# CITY OF HOLLADAY PLANNING COMMISSION MEETING AGENDA

Date: Tuesday, March 4, 2014  
Location: Holladay Municipal Center - 4580 S 2300 E  
Time: 7:00 PM

**Project Name:** Broadbent Stream Exception  
**Application Type:** Request special review of pool construction with 100' stream protection buffer  
**Nature of Discussion:** Discussion with possible decision  
**Notice:** Mailed February 21, 2014  
**Planner:** Jonathan Teerlink and Clarence Kemp, City Engineer

**Request:** Seeking an exception to construction within 100' of perennial streams  
**Project No:** 12-09-02  
**Address:** 2712 E Hillsden Drive  
**Applicant:** Jeff Robinson as agent to Natalie Broadbent  
**Zone:** R-1-43

Layout/Grading  
Plan

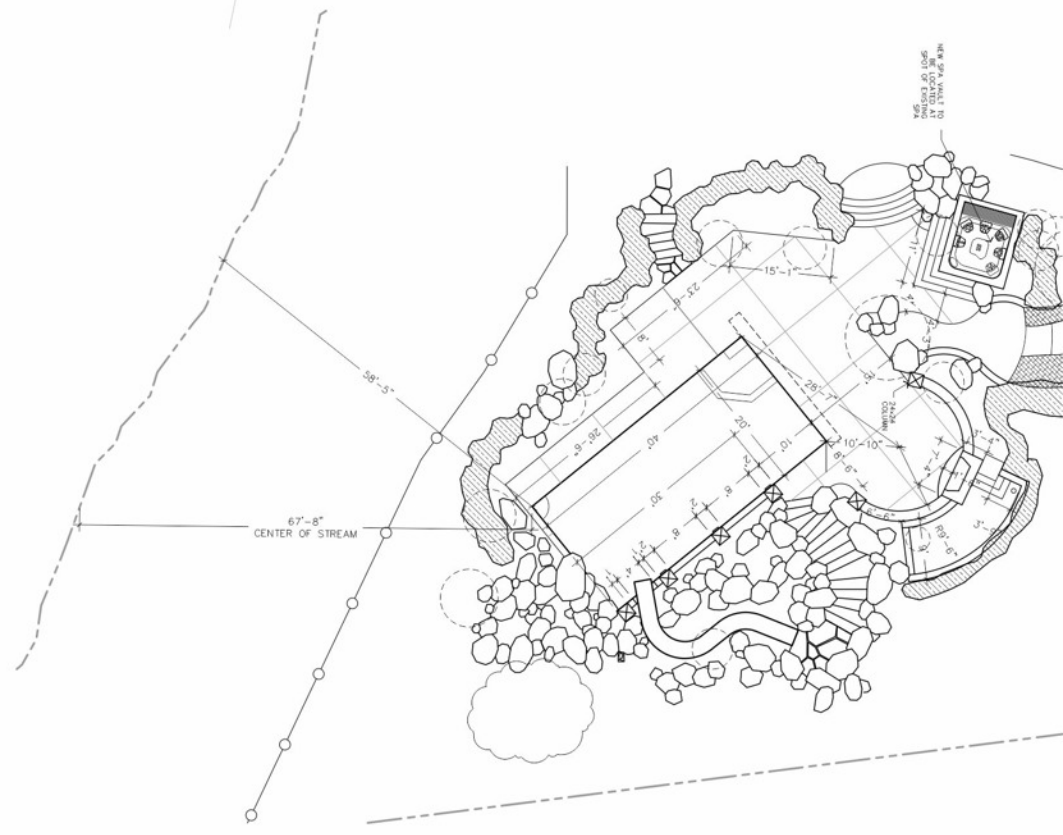
The applicant is requesting special review of proposed pool construction at a distance of 68' including rip-rap wall and pool decking at a distance of 59' from the middle of Big Cottonwood Creek.

1. There is no stream course alteration is proposed
2. No living structures are proposed with a FEMA floodplain
3. The area where the pool is to be constructed is not considered wetlands.
4. The pool equipment including mechanical and chemical storage is outside of the 100' protection area
5. The proposal does not require review of other agencies.

6. The proposed building is not located within the FEMA floodway
7. No bank disturbance within the stream protection corridor.
8. The property is currently developed with a home built within 30' of Big Cottonwood Creek which existing prior to Holladay incorporation and stream protection ordinances.

1. The pool equipment (mechanical and chemical) to be located greater than 100' from Big Cottonwood Stream.
2. Swimming pool improvements shall be placed no closer to the center of Big Cottonwood Creek than 68'

3. Limit of disturbance/silt fencing shall be set at contour elevation 4455' with all pool excavation work completed from the uphill side of said limit of disturbance.

4. Placement of pool decking and rip-rap boulders between 59' and 49' from the centerline of Big Cottonwood Creek shall commence only from the uphill side of 4455'.

5. Landscaping of stream bank as per submitted plans shall be part of this approval and shall be including as an item of the final inspection of the pool.

6. All future landscaping, flatwork, and grading, 59' of the centerline of Big Cottonwood Creek must be approved by the Community Development Director and City Engineer prior to commencing work.

7. Best construction management practices are to be followed to prevent pollution of water that may enter the stream system during construction. Specifically, the limit of disturbance fencing and silt erosion control fencing shall be installed prior at the time of pool layout maintained throughout the duration of project.

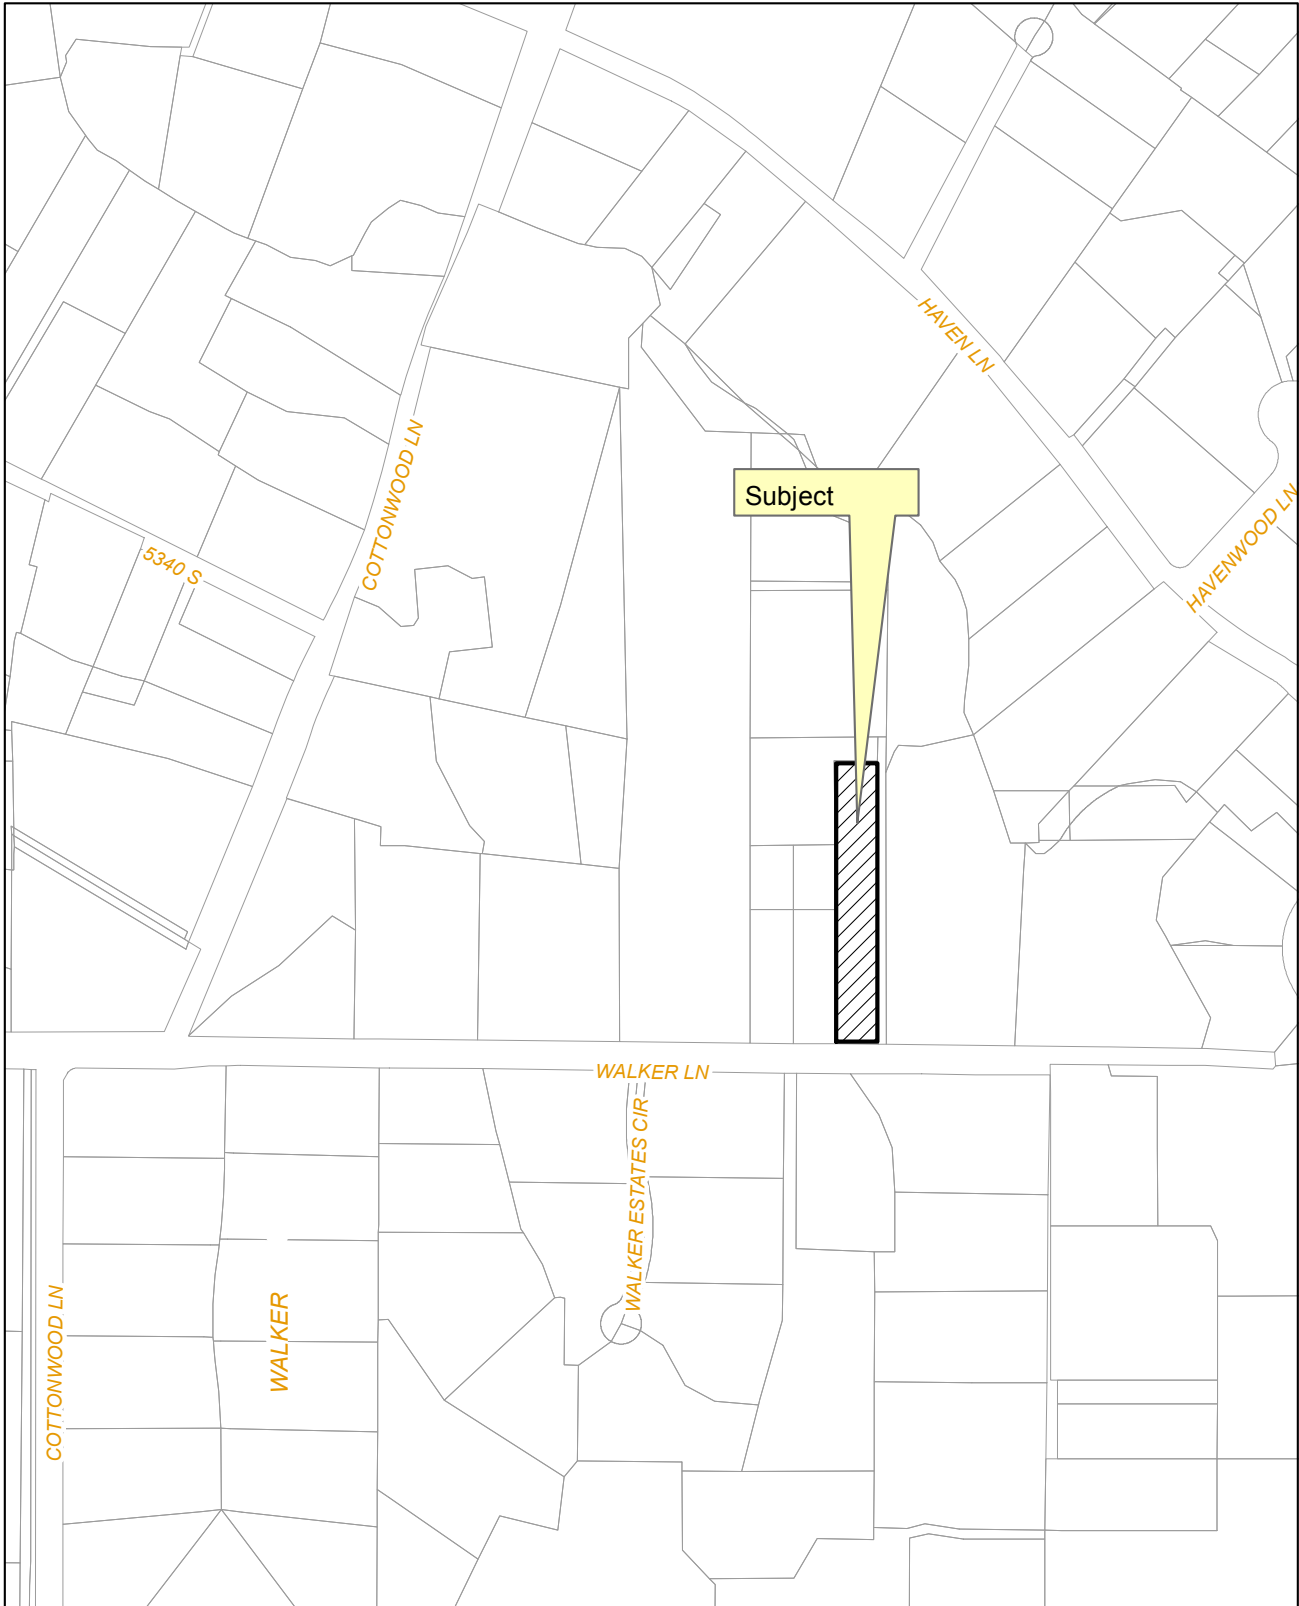
- 1) **13.14.110:** A 9' minimum setback is required for accessory buildings on lots of this size. The west setback is proposed at 11'. Proposed project complies with this regulation

- 2) **13.17.090:** No accessory building(s) shall cover more than 25% percent of the rear yard. The rear yard setback for a lot of this size is 41'. The garage (with proposed addition) is currently setback a distance of 50' from the rear/north property line. Technically, this garage is not located in the rear yard as defined by Holladay code but rather located within the building envelope for a single family home. The side/west setback of the proposed garage is 11' from property line, which does not violate the side setback for a home at this location which is 8.5' or 10% of the lot width. Proposed project complies with this regulation

- 3) **13.17.110B:** Graduated height rules dictates a max wall height of 17' when the required 9' setback is applied. At the proposed setback of 11' a 19' wall would be the maximum allowable wall height. The new garage addition is 11.5' tall and which complies with this regulation. Also, the maximum height allowed for accessory building(s) is 20'. The proposed overall height of the garage addition is 19' 1 1/2" measured from existing grade to ridge. This proposal complies with max height allowances

- 4) Storm water drainage shall be retained onsite so as to not drain across property lines
- 5) Access to this garage is limited to existing driveways serving the existing garage.

1. That the proposed accessory building elevations match or are compatible with the existing façade treatment of the existing garage. In this case brick exterior.
2. City engineer approved storm water retention plan be submitted
3. Garage security lighting, if any, be a full hood cut-off fixture and mounted in a manner so as to no expose the lighting element(s) to neighboring properties.
4. The setback from the western property line shall show a minimum distance of 11'. This setback area may provide for a hedgerow or tree-lined landscape buffer
5. Architectural treatments shall be retained as proposed or similar as to match the existing garage.

# DREYFOUS FARMS - PRELIMINARY PLAT

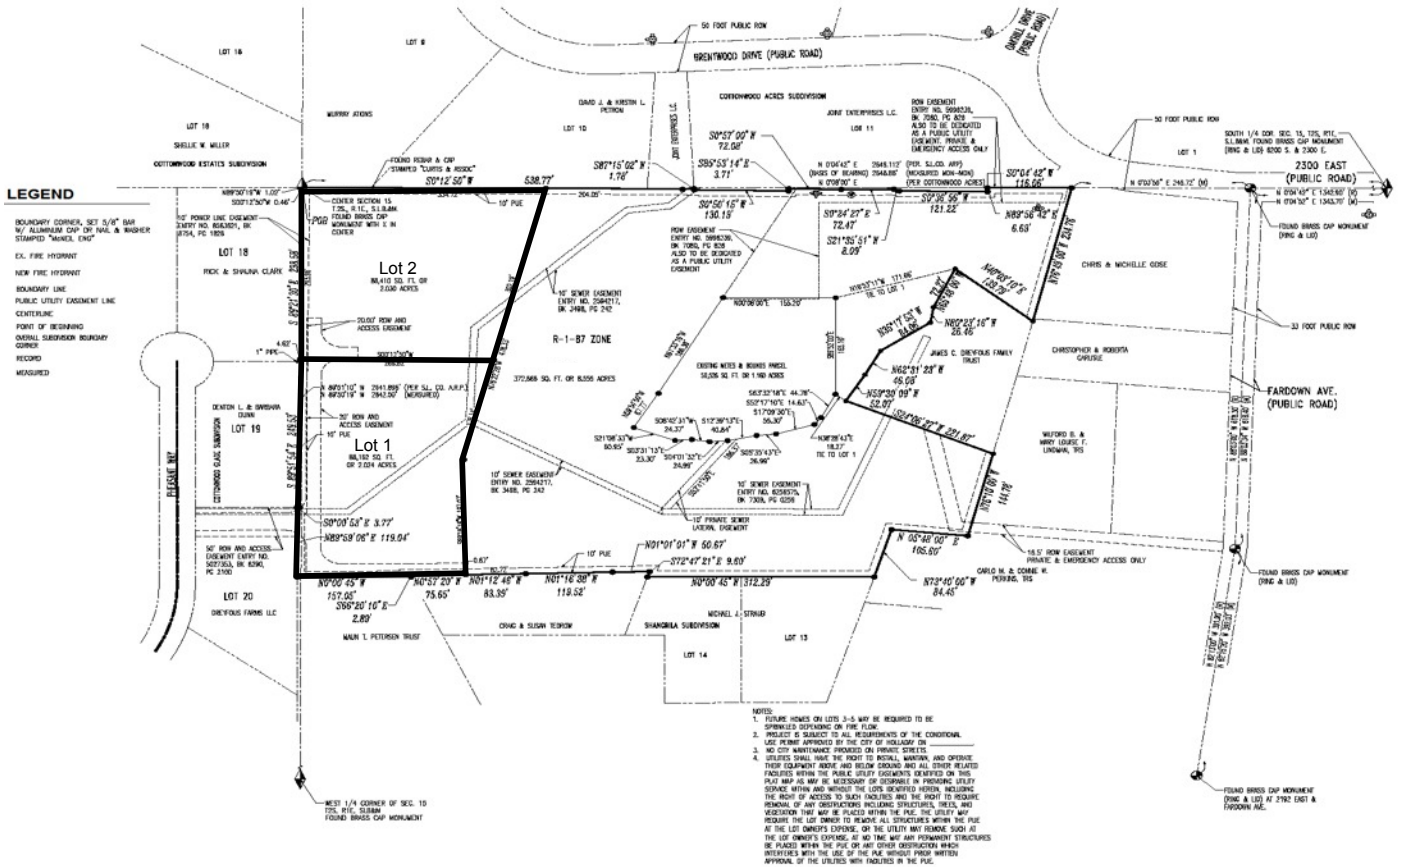
- *Preliminary Plat* – Drawing is attached.
- *Density and Lot Area* – Current zoning allows one single family residence on 2-acre minimum sized lots. This project meets the minimum lot area requirements for the R-1-87 zone.

- *Drainage and Water Retention* – The City Engineer has indicated that an acceptable drainage and water retention plan will be required prior to Final Plat approval.

- *Road Access* – Road access for both new lots is proposed via a right-of-way easement over Lot 20 of the Cottonwood Glade Subdivision. No access to 2300 East or Far Down Ave. is requested, anticipated or recommended.

- *Access and Right-of-Way* – A Right-of-Way Easement and Road Maintenance Agreement for the two proposed lots must be recorded with the final plat. This must detail provisions and responsibility for road maintenance, snow removal and etc.

- *Private Road Standards* – The developer must submit design and engineering plans detailing the proposed construction of the private roadway. This design must meet City standards as determined by the City Engineer.

- *Fire Access* –The UFA has approved the Preliminary Plat with regard to fire access and protection. Placement of fire hydrants must meet UFA standards.

1. Any remaining issues with regard to the Preliminary Plat must be resolved per requirements of the TRC;
2. A Final Plat and any other requirements for the subdivision shall be submitted to the Technical Review Committee (TRC) for review;

3. The City Engineer must approve a storm drainage and water retention plan prior to Final Plat submission; and
4. The City Engineer must approve road design and construction details prior to Final Plat submission;

5. The City Engineer will determine appropriate financial requirements for improvements and/or bonding in conjunction with Final Plat approval;
6. A Right-of-Way Easement and Road Maintenance Agreement for the two proposed lots must be recorded with the final plat. It must detail provisions and responsibility for access, maintenance, snow removal, etc;

7. A plat note shall be added to the Final Plat that indicates that “under no circumstances will a connecting roadway allowing public access between Pheasant Way and Far Down Ave. and 2300 East be allowed;” and
